**Project Metrolink Railway Order  
Estuary to Charlemont via Dublin Airport  
(ABP-314724-22)**

Statement of Evidence

Tunnelling Induced Ground Movements & Building Damage Assessment

**Project Metrolink:  
Refined Phase 2a Building Damage Assessment  
(BDA) for Arthur Cox Building, Earlsfort Terrace**

Figure 4-1 Site Investigation Location Plan [from Figure 20.6 (Sheet 7 of 8) in Chapter 20 of the EIAR]

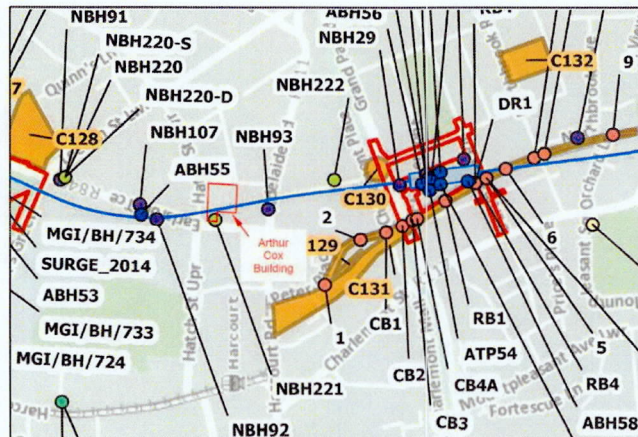
- Arthur Cox Building (B-238): Case B “Special Building”
  - 8.1m deep basement
  - Height = 40m (7 Floors + 2 Basement Levels)
  - Ch. 18+945 to 18+995 (50m)
- Ground Loss Parameters (Conservative):
  - **0.75%** (Tunnel in rock with  $>0.5D$  rock cover):  
*Ch.18+960 to Ch.18+980*
  - **1.50%** (Tunnel in rock with  $<0.5D$  rock cover):  
 *$<Ch.18+960$  &  $>Ch.18+980$*
  - Trough Width Parameter, **K = 0.40**
- Profile shows building and secant pile wall supported in glacial till over weathered rock.
- Boreholes not included in EIAR – notable omission
- Boreholes NBH-92 and NBH-93 mislabeled or not carried out – no logs.

Figure 4-2 Geological Cross-Section [Sheet 26 of 28 from Appendix A20.9 to Chapter 20 of the EIAR]

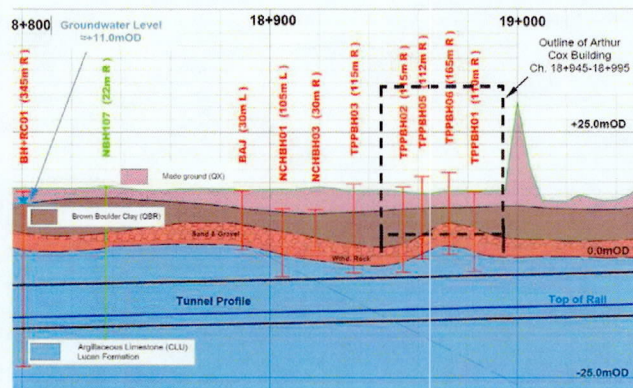
- Site specific SI information: building is on rock and secant pile wall is socketed 3.5-4.0m into rock below the basement => geological profile in EIAR is incorrect.
- Use *Refined* Phase 2a Ground Loss Parameters from BDR:
  - **0.5%**: Tunnel in rock with  $>0.5D$  rock cover
  - **1.0%**: Mixed soil/rock or rock with  $<0.5D$  rock cover
- Representative of modern tunnelling equipment & control systems.
- Consistent with experience on Dublin Port Tunnel.
- 0.5% ground loss most relevant to tunnelling in rock under Arthur Cox Building
- Does not account for concentrated foundation loads => calculations for 1.0% ground loss included as upper bound to assess sensitivity of analysis.
